Attachment 1

St. Lucie Unit 2 Marked-Up Technical Specification Pages

2-8 (with insert)
3/4 2-4 (with insert)
3/4 2-12 (with insert)

Attachment 2

FIGURE 2.2-2

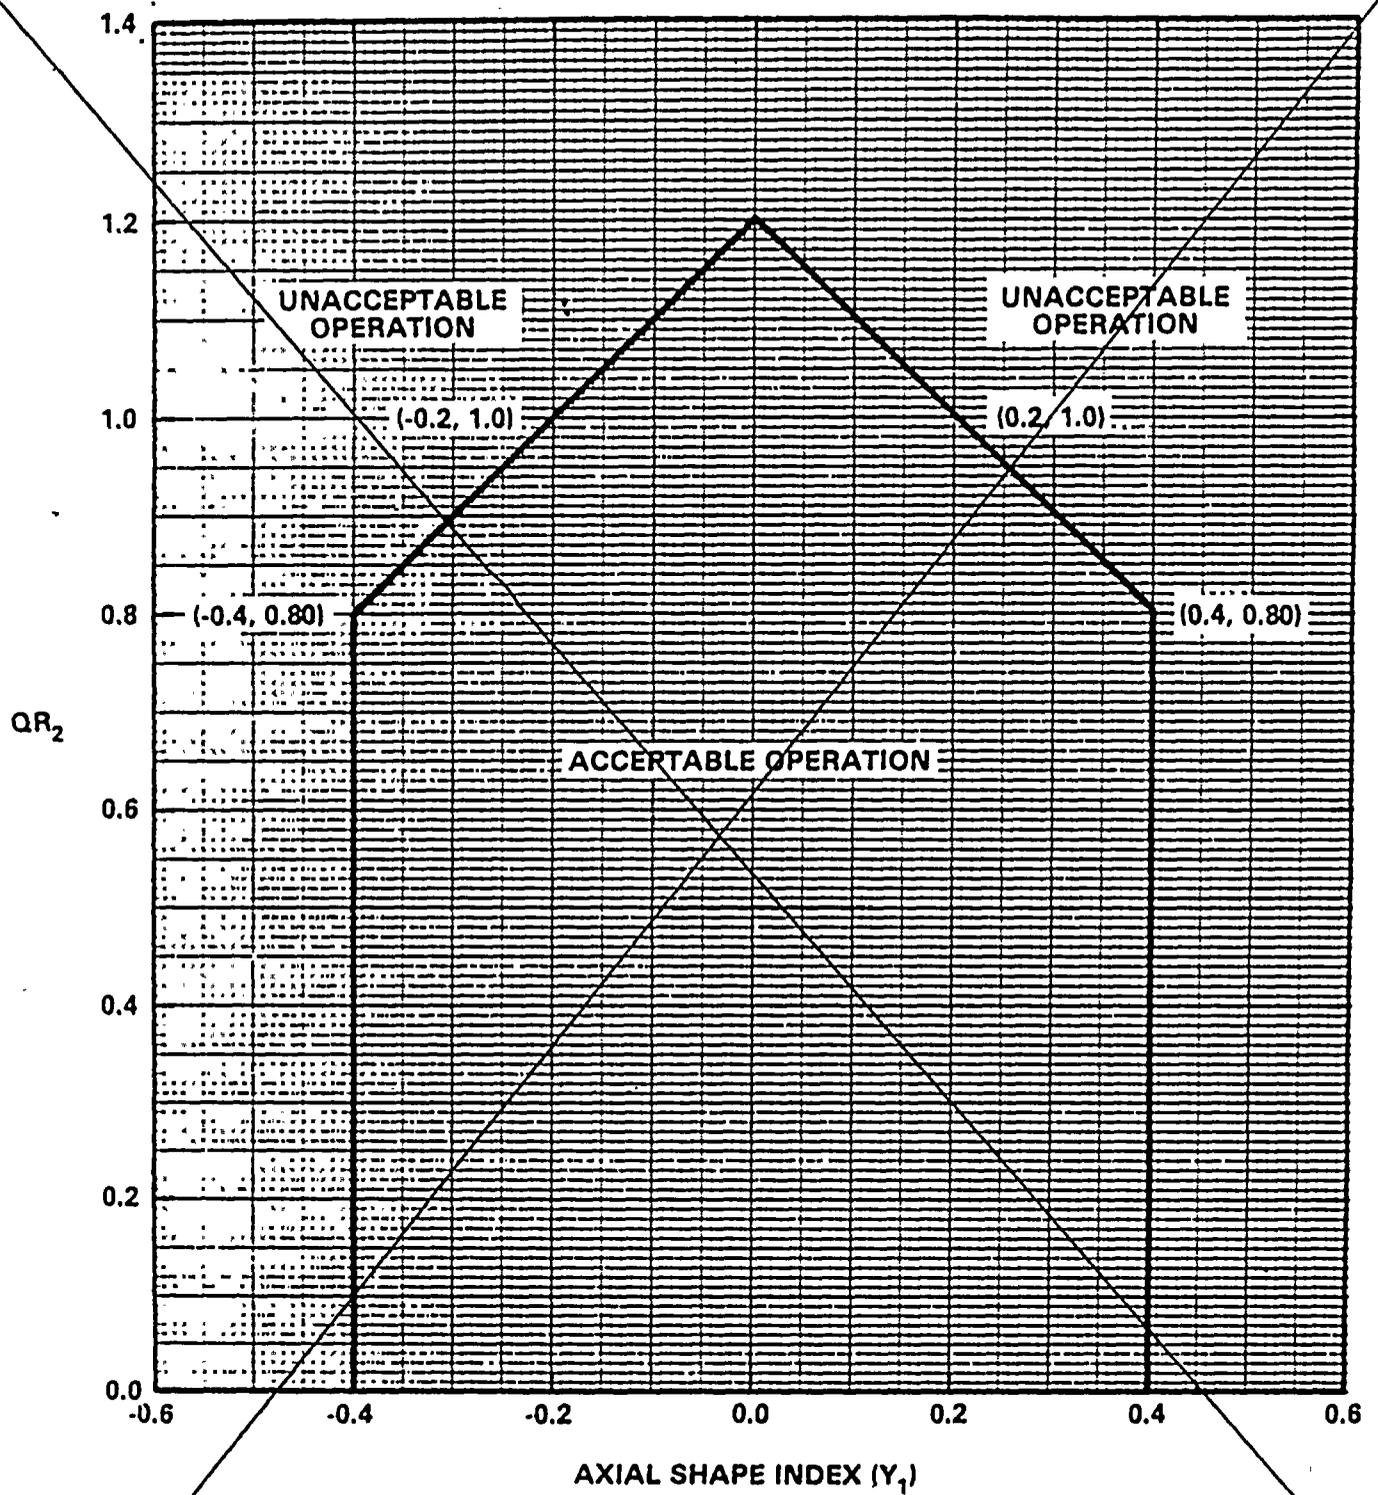
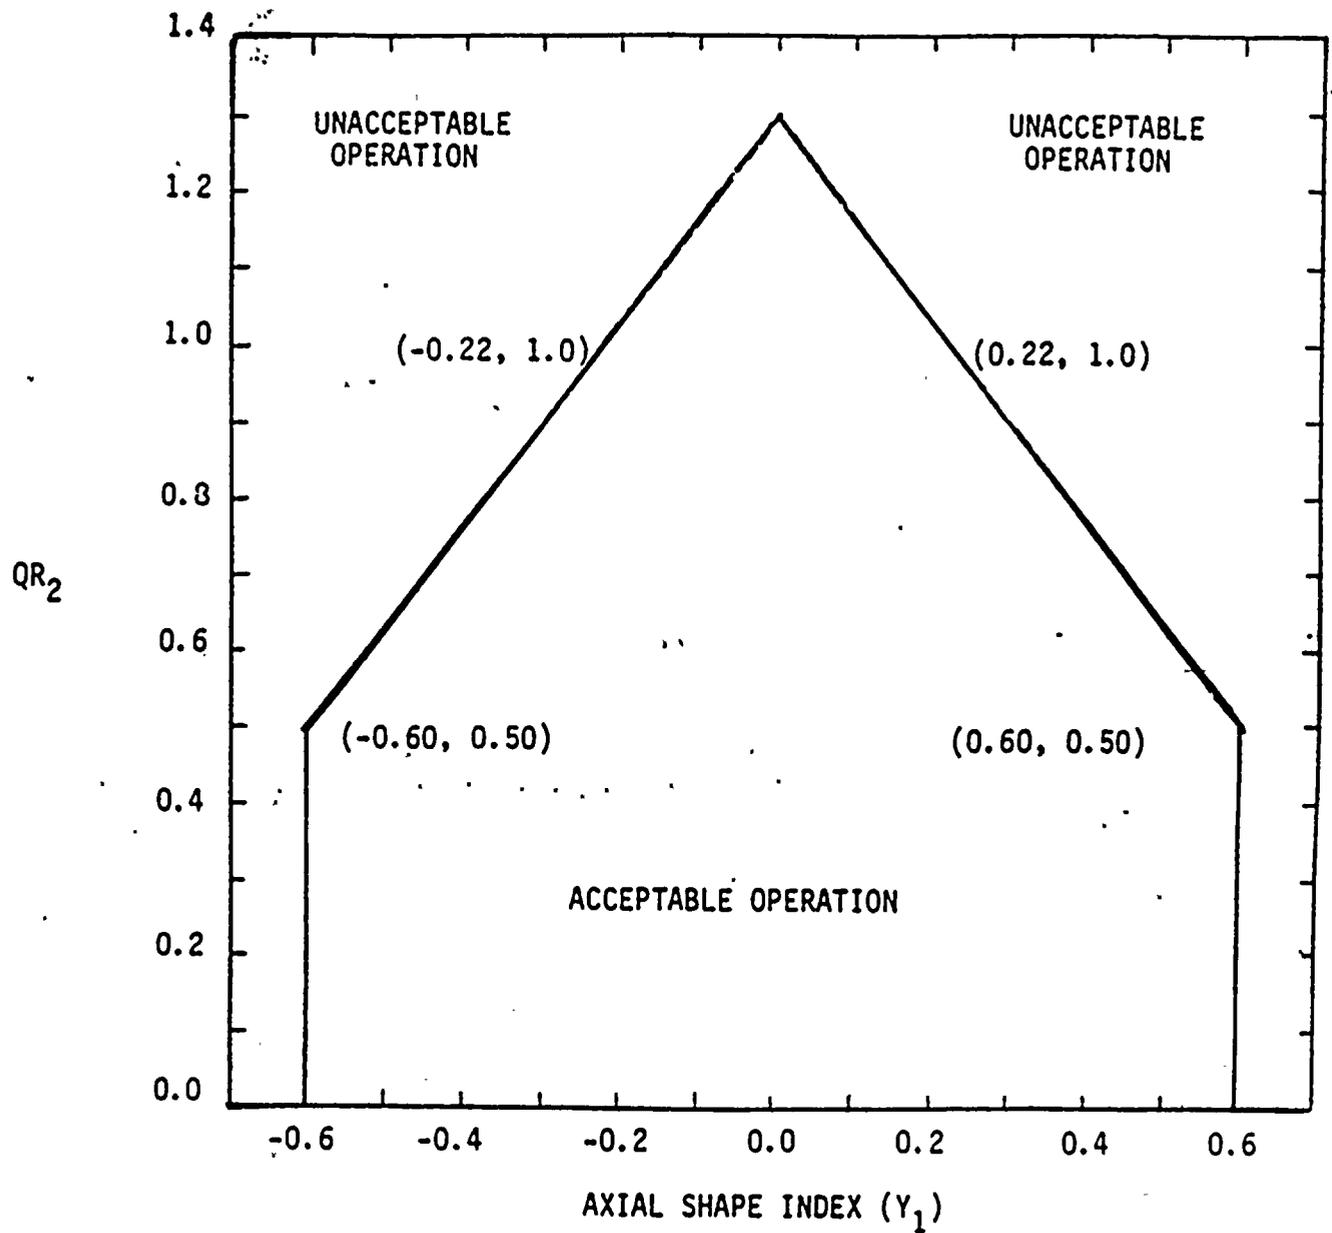
*Replace with
 Insert Attached*

It is proposed to expand the LPD LSSS ASI limits for power levels below 50% from ± 0.4 to ± 0.6 , to expand the ASI limits of the LHR LCO for powers below 60% (but above 40%) and the ASI limits of the DNB LCO for powers below 65% (but above 40%) from ± 0.3 to ± 0.5 . For Figure 2.2-2, it is also proposed to increase the ASI limits slightly above 0.8 of rated power and to raise the apex of the curve from 1.2 to 1.3.

The analyses described above showed that in all cases margin still exists between the expanded Technical Specification limits and the calculated limiting values. In the case of the LPD LSSS limits (Figure 2.2-2) the closest approach to the actual calculated LSSS limits occurs at 66% power and an ASI of +.48. At this limiting power level/ASI pair a margin of 12% still exists. For the DNB LCO (Figure 3.2-2) the point of minimum margin occurs at 100% power for an ASI of -0.08. The CEA subgroup drop event sets the ROPM for these limits. At this limiting power level/ASI pair, a margin of 5% still exists. In the case of the LHR LCO (Figure 3.2-4) the point of minimum margin occurs at 88% power for an ASI of -0.15. At this limiting power level/ASI pair a margin of 10.5% still exists. The LCO limits in this case are set by the Large Break Loss of Coolant Accident (LOCA) kw/ft limit.

FIGURE 3.2-2

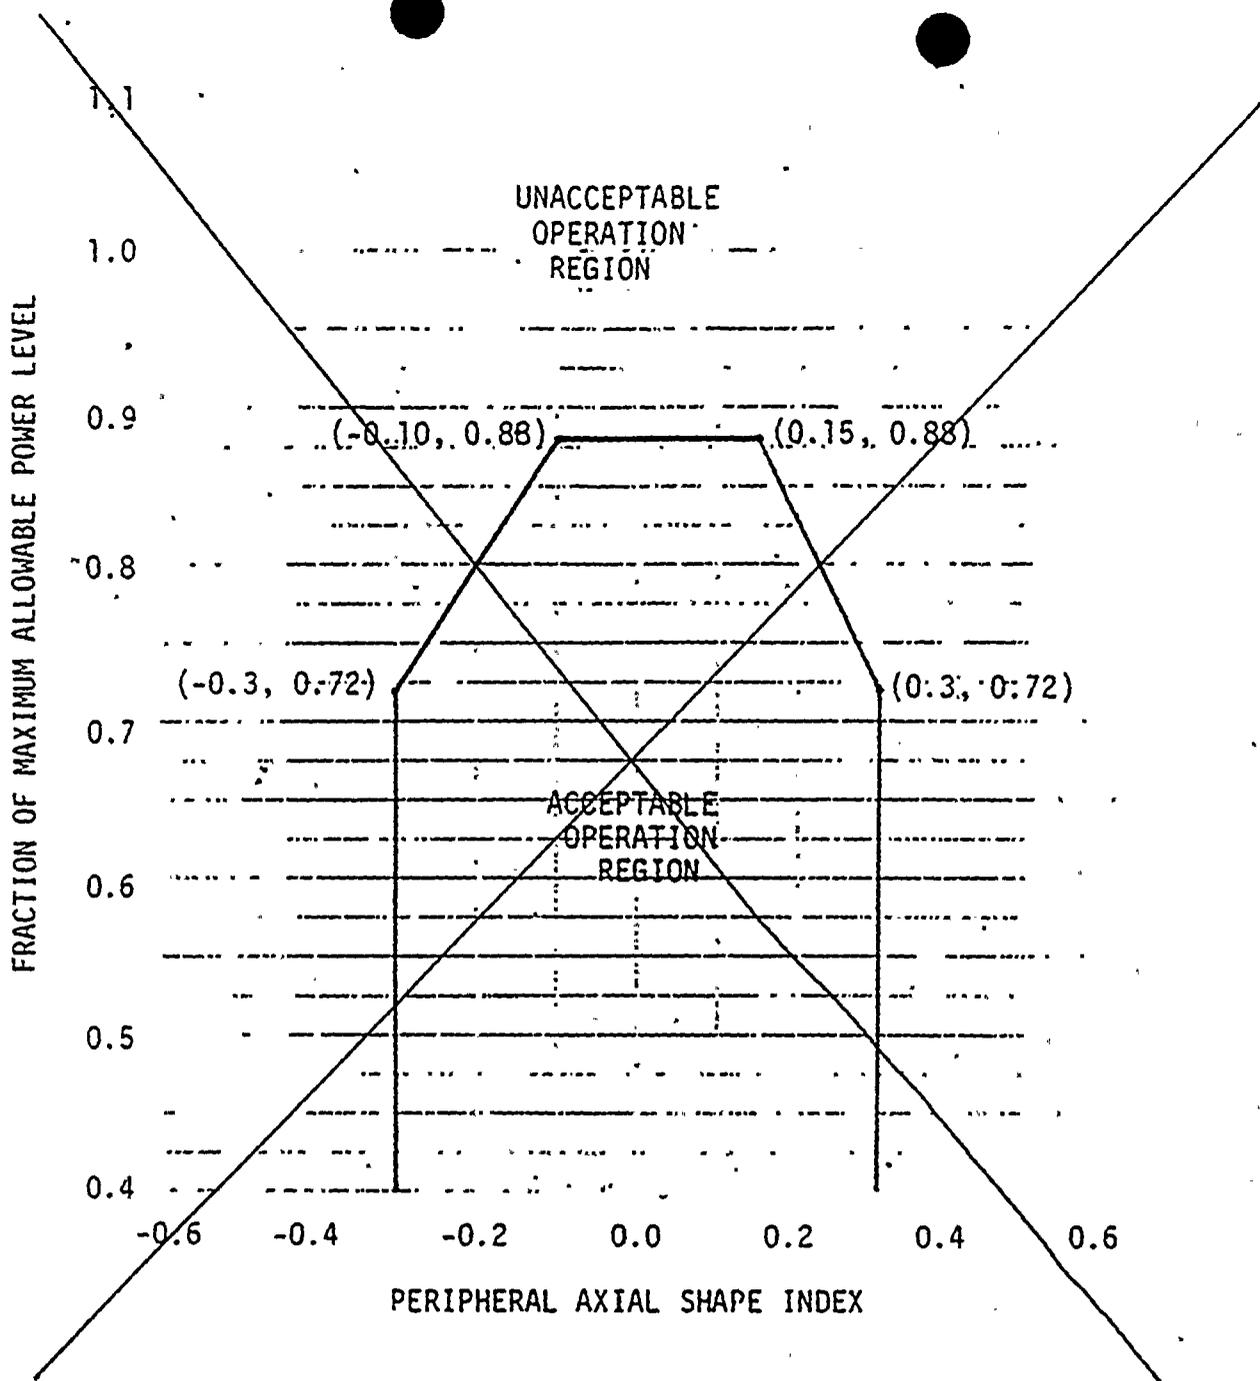
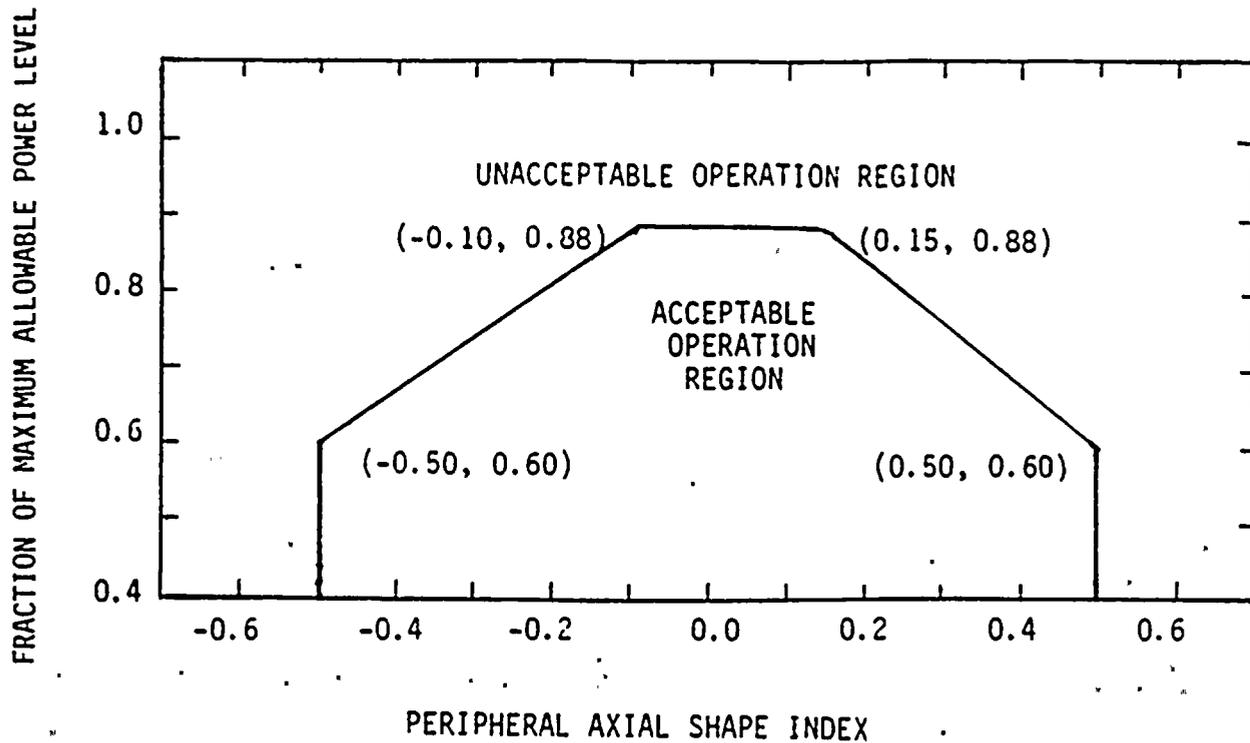
Replace with
Insert Attached

The results of the setpoint evaluations described above are shown in proposed revised Figures 2.2-2, 3.2-2, and 3.2-4. The ASI limits on each of these figures remain the same as the current Technical Specification limits above 65% power except for the LPD LSSS (see Figure 2.2-2). It should be noted that the LPD trip is not the primary trip in the safety analysis of any Design Basis Event (DBE). However, the LPD trip ensures that the peak local power density in the fuel remains below that corresponding to fuel centerline melting as a consequence of axial power shape maldistributions. Since this trip is not the primary trip for any DBE, no events analyzed for the safety analysis are adversely effected, by the slight increase in the ASI limits above 0.8 fraction of rated power. The same is also true for the increase in the apex of Figure 2.2-2 from 1.2 to 1.3, since core power is limited by the Variable Power Trip - High whose setpoint is 107% of rated full power.

FIGURE 3.2-4

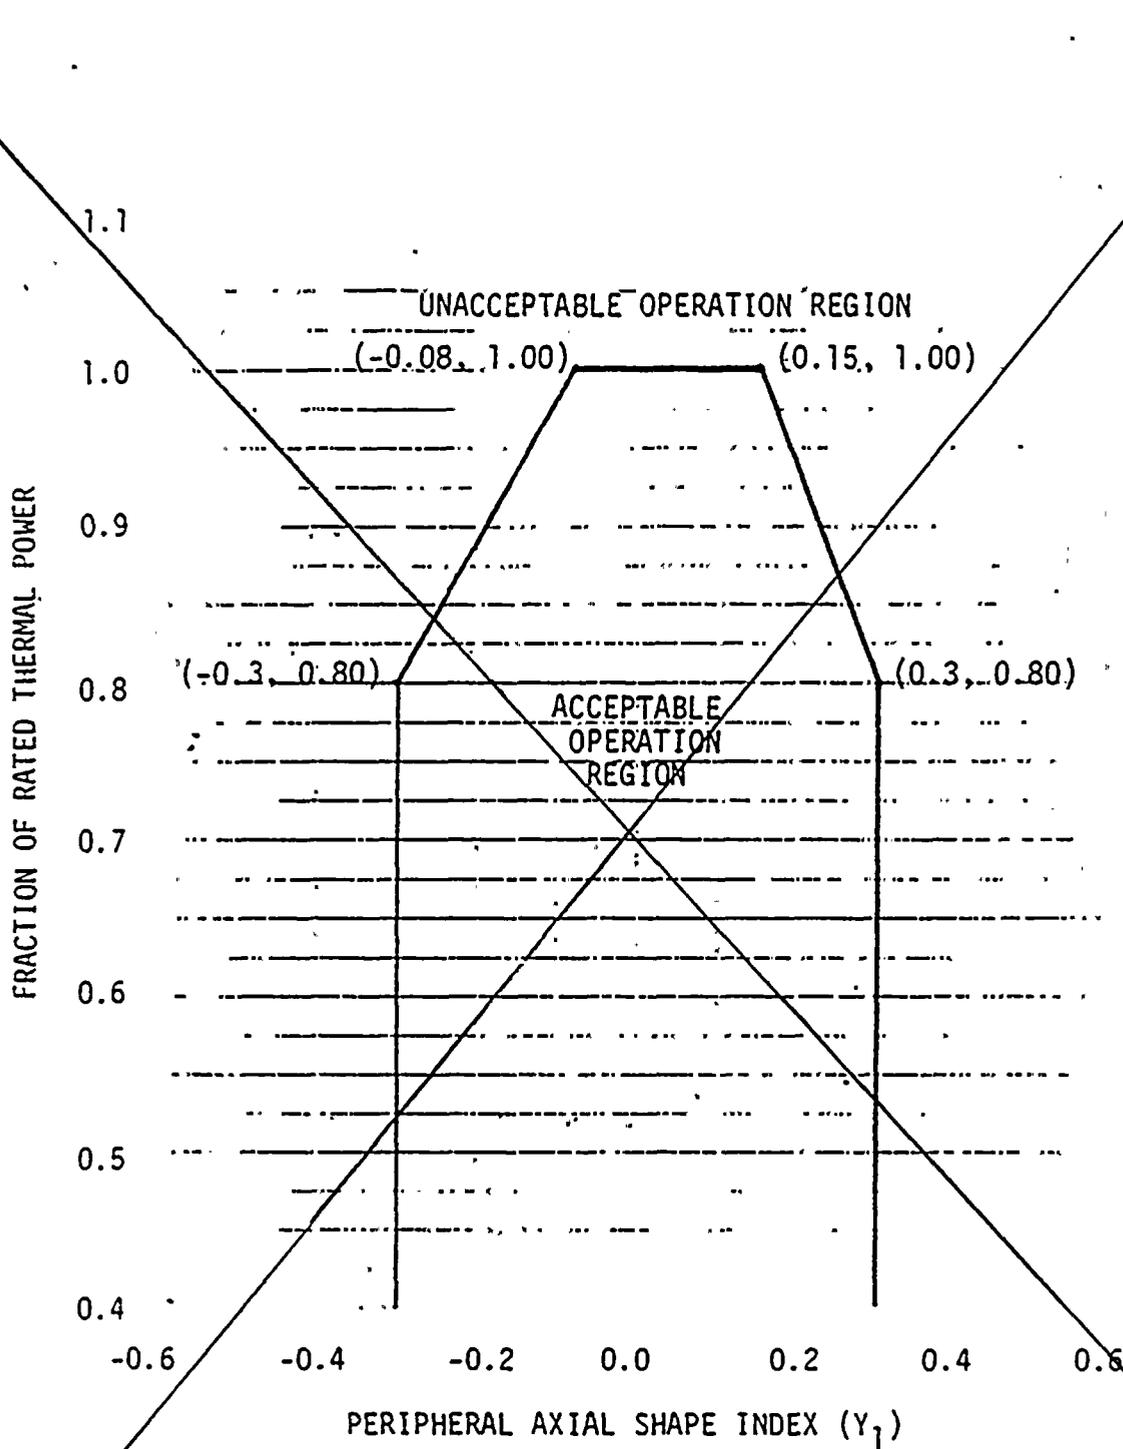
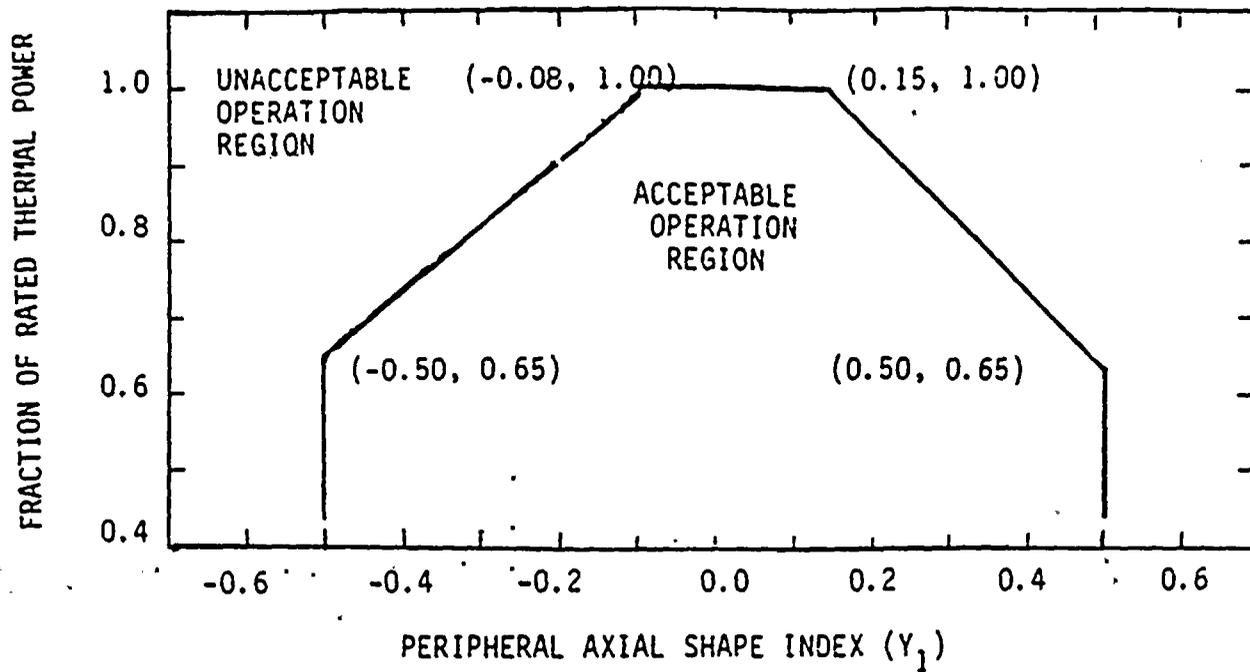
*Replace with
Insert Attached*
